Design Hazard Review: DSRP Bench Unit

SLIPSTREAM PILOT TEST UNITS FOR DIRECT SULFUR RECOVERY PROCESS AND ADVANCED HOT GAS PROCESS

August 2000

DSRP FIELD TEST PILOT UNIT P&ID - SULFUR COLLECTION <small>Direct Sulfur Recovery Process</small> <small>Mobile, AL</small>	DOE/FETC <small>NO. K</small>
--	---

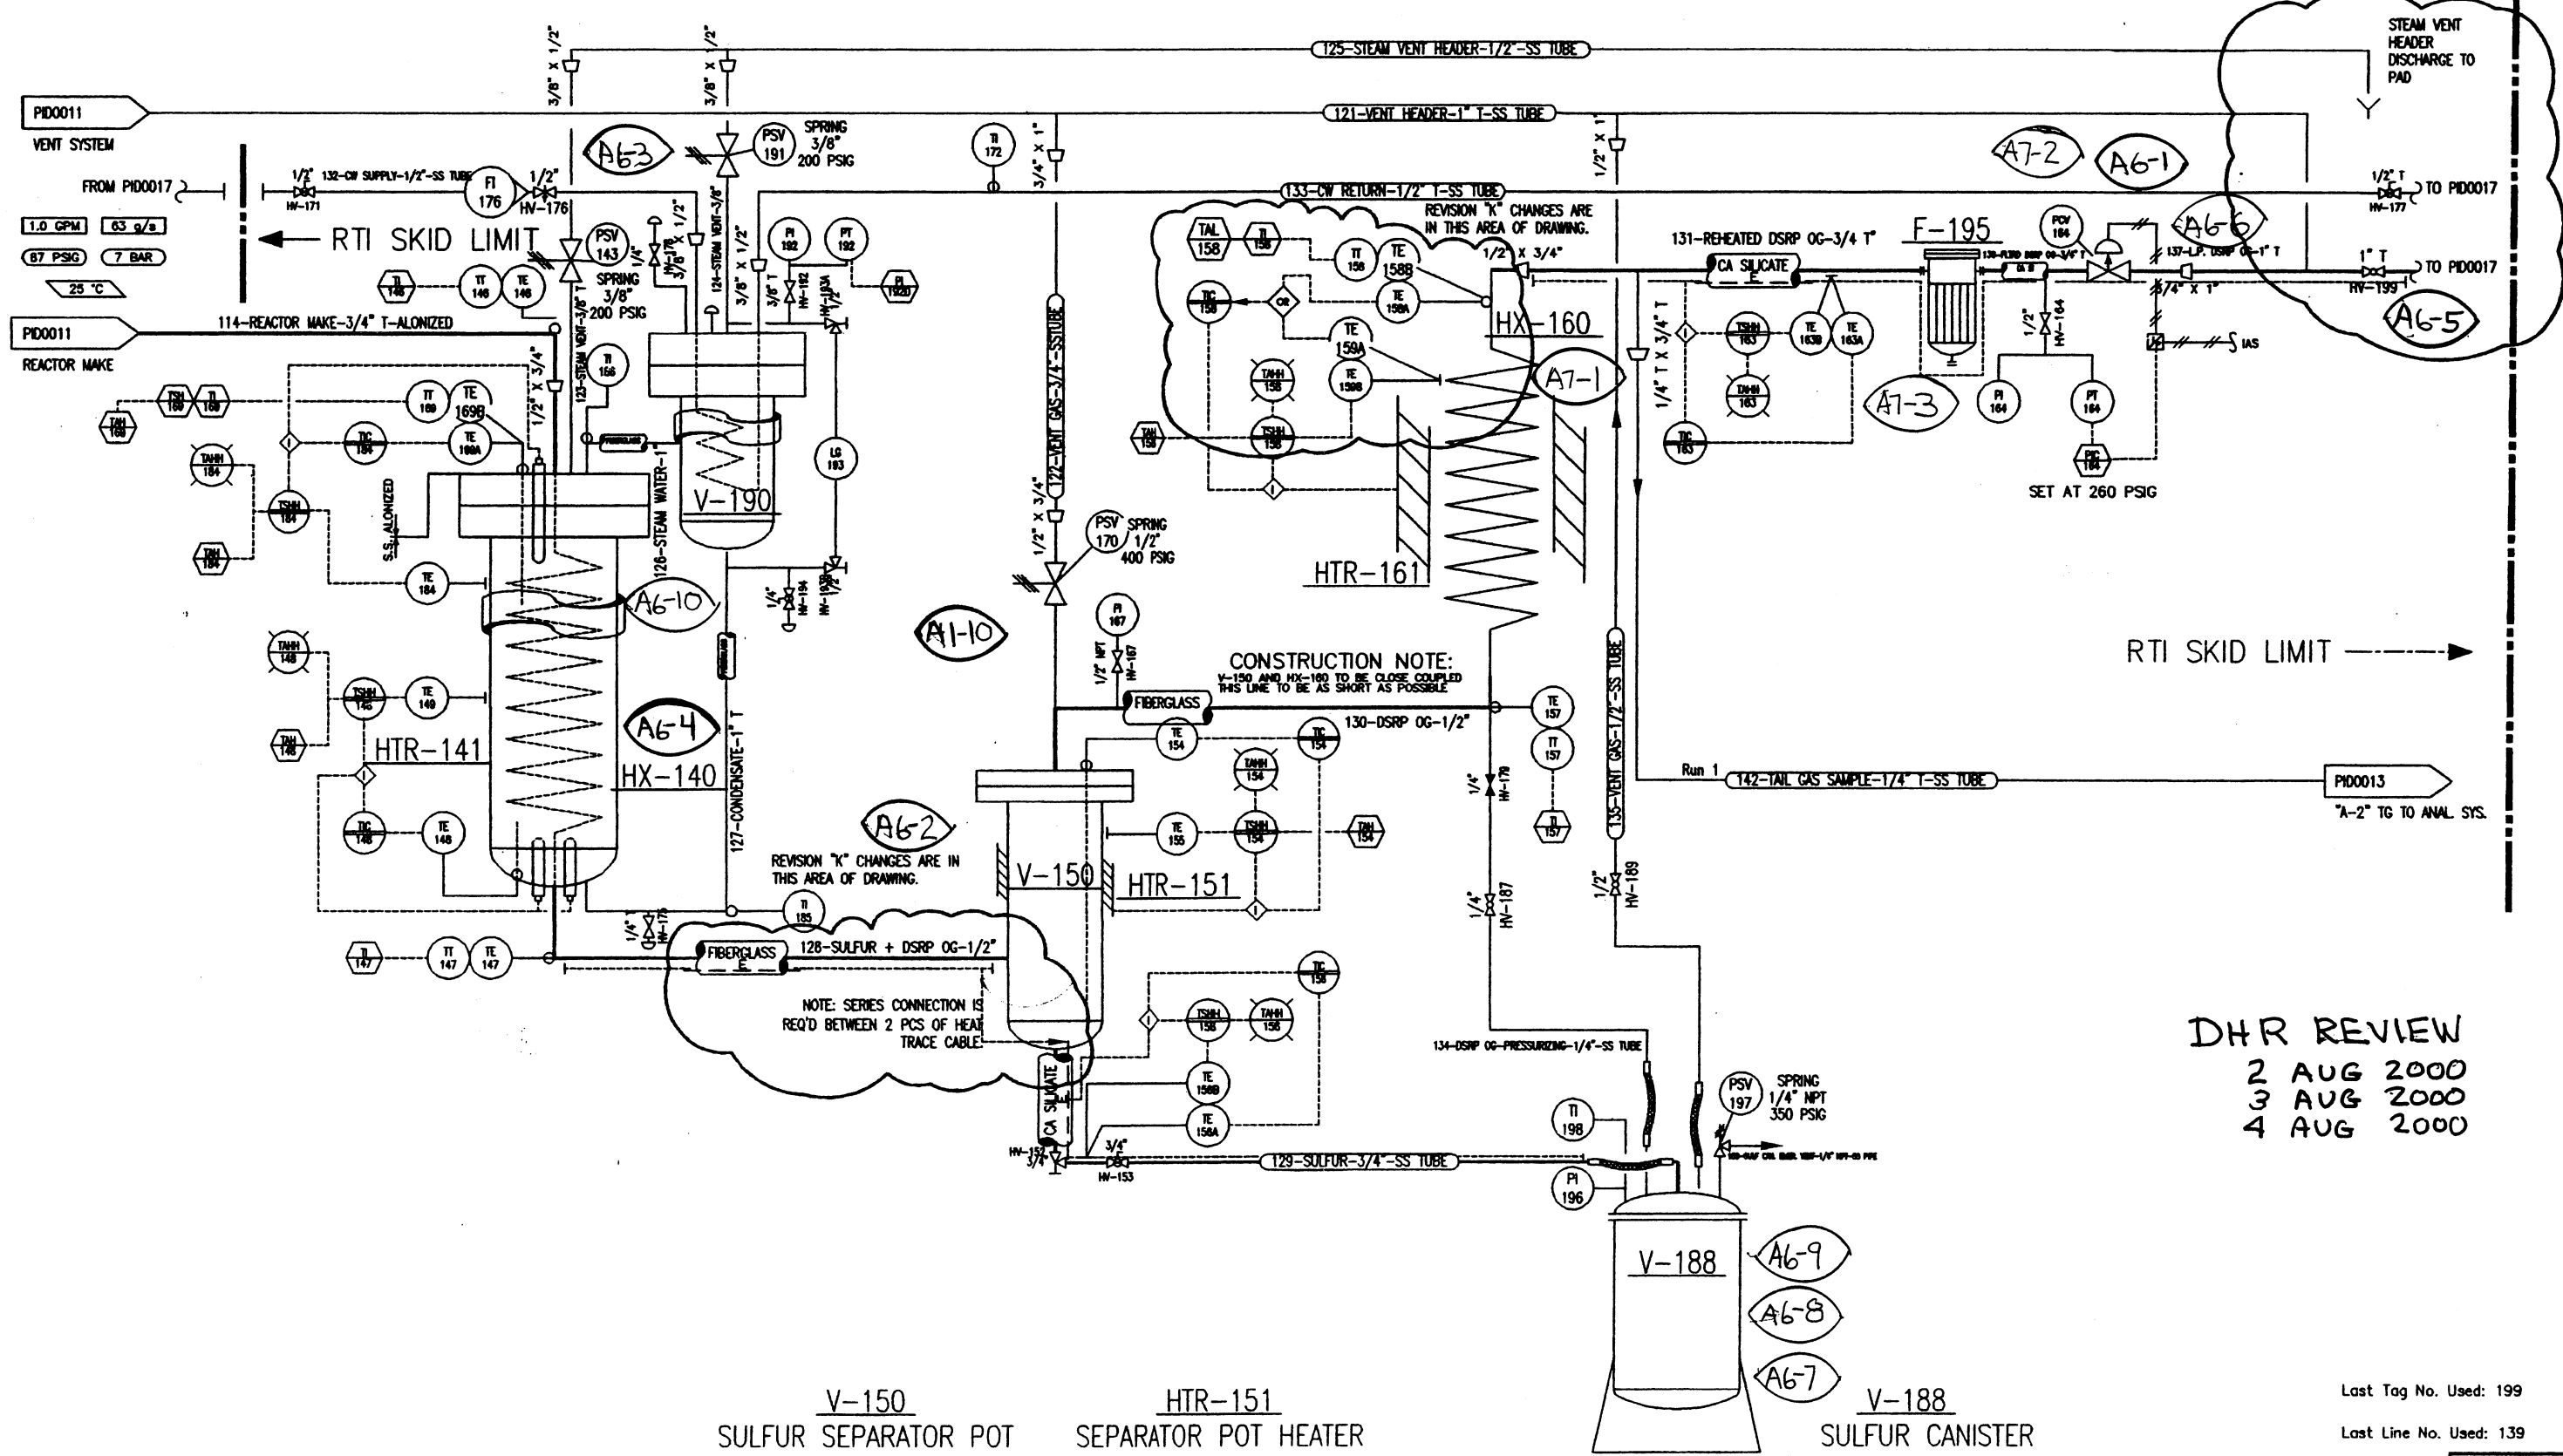
A6-4	PID-0012 HX-140 Condenser coil	Maintenance hazard.	Removal of coil following failure.	S-Personnel hazard. Operator must climb skid for access to HX-140/V-190.	None.	Develop fall protection plan.	RTI	
A6-5	PID-0012 DSRP	Maintenance hazard DSRP under vent header pressure.	RTI operator opens DSRP process containment equipment while KBR is running.	S-Personnel hazard and potential for operator injury.		Consider providing double block and bleeds for syngas, nitrogen, and tail gas at RTI skid for maintenance. Consider providing additional bleed off to relieve system pressure to L.P. vent header/K.O. POT (refer to A6-3).	RTI

A6-8	PID-0012 V-188	Maintenance under pressure.	<ul style="list-style-type: none"> On-line removal of sulfur from V-188. 	<ul style="list-style-type: none"> S-Personnel exposure hazard to toxic gas vented from V-188. V-188 depressured to vent header. 		<ul style="list-style-type: none"> Provide high point atmospheric vent for V-188 to safe location. Develop a design for on-line venting and discharge. 	RTI	<ul style="list-style-type: none"> Review design when complete.
A6-9	PID-0012 V-188	Maintenance under pressure.	<ul style="list-style-type: none"> On-line removal of sulfur V-188. 	<ul style="list-style-type: none"> S-Personnel exposure to residual gas remaining in V-188. 		<ul style="list-style-type: none"> Review requirement and provide procedure for wearing respirator during V-188 disassembly and disconnect for sulfur removal. Consider personnel monitor. 	RTI/SCS	
A6-10	PID-0012 HX-140 V-190	No flow. Loss of cooling water.	<ul style="list-style-type: none"> Supply valve inadvertently closed. 	<ul style="list-style-type: none"> S-Potential for steam generated overpressure in V-190/HX-140. 	PSV-143/PSV-191 relief valves.	<ul style="list-style-type: none"> Verify criteria sizing PSVs and flow rates and discharge capacities. 	RTI

A7-3	PID-0012 Line 136/137 DSRP OG	High pressure. Plugged line/filter.	Local heater failure and/or cold spot.	O- Operability upset. Unable to control back pressure. Potential for overpressuring equipment. Unable to depressure.	System/equipment PSVs.	Identify required bleed points for final depressuring prior to breaking into pressure containment equipment (refer to A6-5). Review need to vent tailgas at thermal oxidizer for plugged line.	RTI SCS

DHR REVIEW
4 AUG 2000

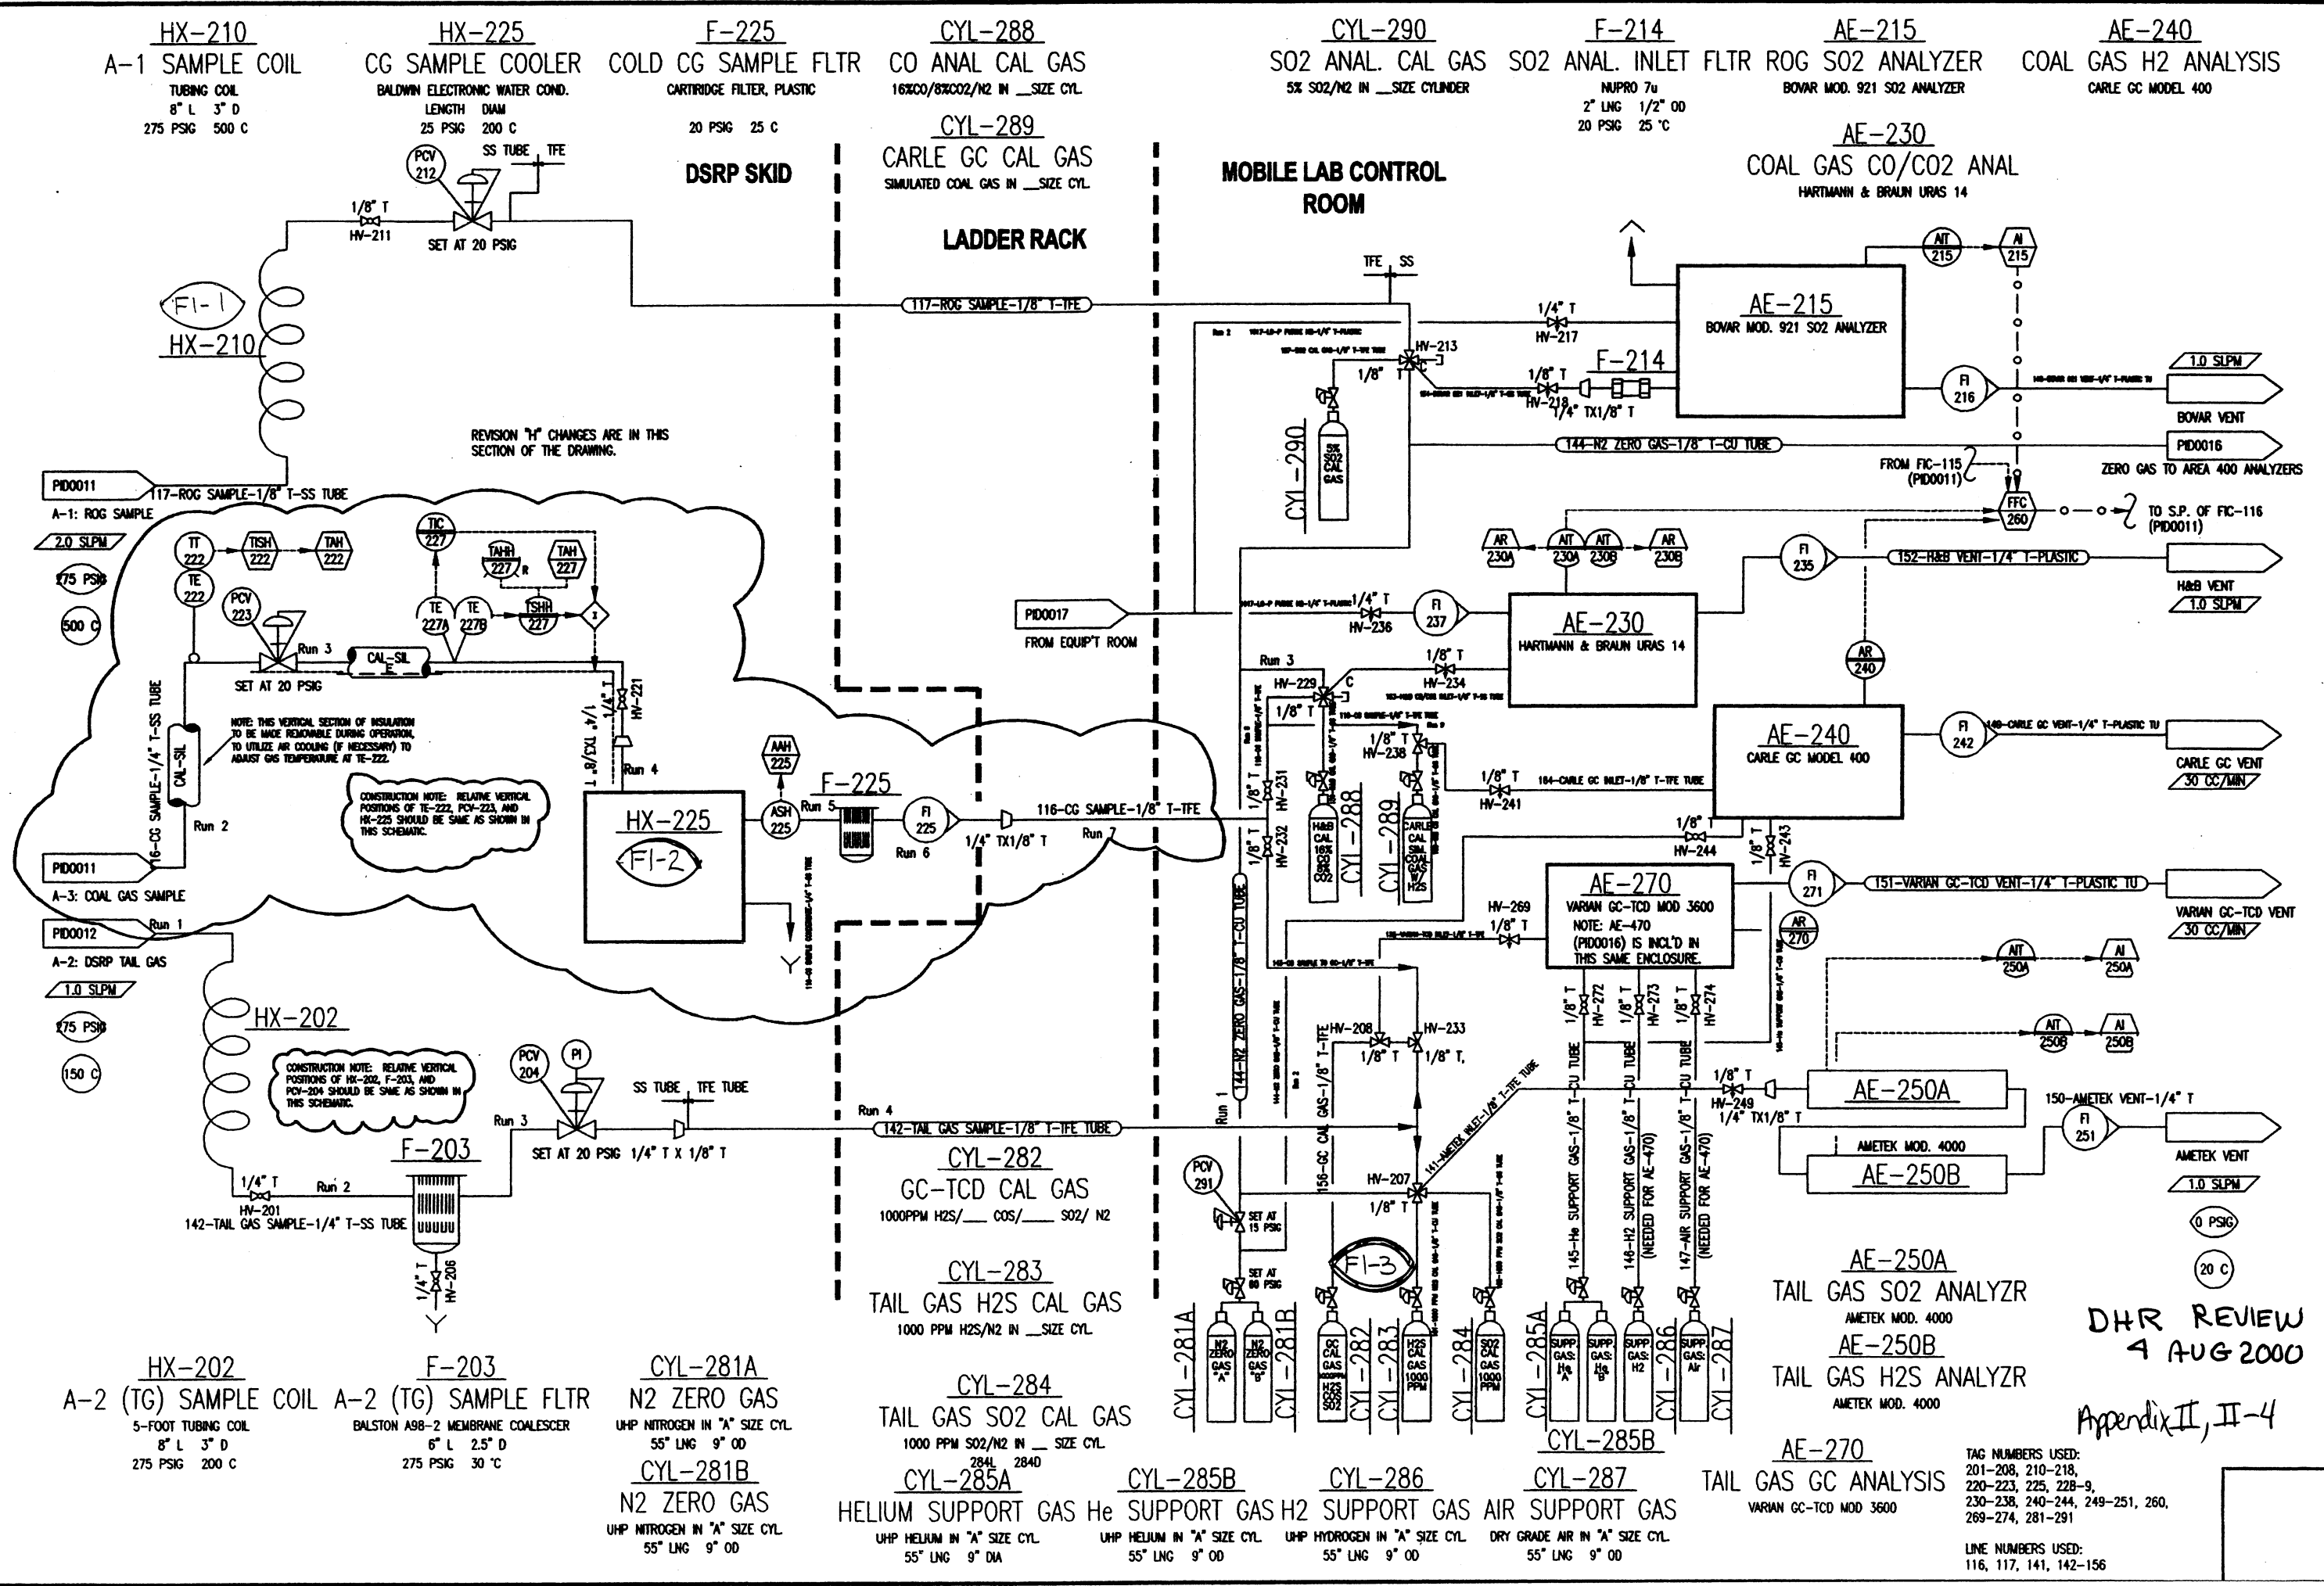
B1-3	PID-0014 PCV-303 PCV-306	High pressure. 1800 psig H ₂ S and air cylinders feed AHGP.	PCV-303 or PCV-306 fails.	S-System overpressure. Potential equipment damage. Potential personnel hazard.	PCV regulators show built-in overpressure relief valves.	Confirm that a relief valve is integrated into regulator and can protect downstream equipment. Review (TBD) vent design to safe location (refer to A6-3).	RTI

B4-3	PID-0014 Air REGEN feed MFC/FCV-309 MFC/FCV-313	Reverse flow. LSO ₂ backflows into process nitrogen line tie in at HX-325 SO ₂ REGEN PHTR coil.	Product line at/or downstream of R-330 plugs.	O-MFC fails and leaks.	MAWP/temp of MFC.	Consider adding check valve process N2 line 1005. Consider adding check valve in process air line 1004.	RTI	
B4-4	PID-0014 YV-03 Emergency nitrogen purge flow.	High flow. High velocity through R-330.	Emergency S/D valve sequence.	O-Potential for sorbent carryover and distributor damage.		Determine maximum velocity and nitrogen flow rate. Consider installing RO downstream of YV-03 to limit emergency nitrogen purge flow.	RTI	
B4-5	PID-0014 R-330	Process air feed continues after sorbent regeneration is complete.	Operator error.	O-Potential intrusion into thermal oxidizer syngas inlet.	Procedure. TE-338 reactor temperature. Off-gas analyzer monitoring.	Determine maximum flow through FCV-313 required for sorbent regeneration.	RTI
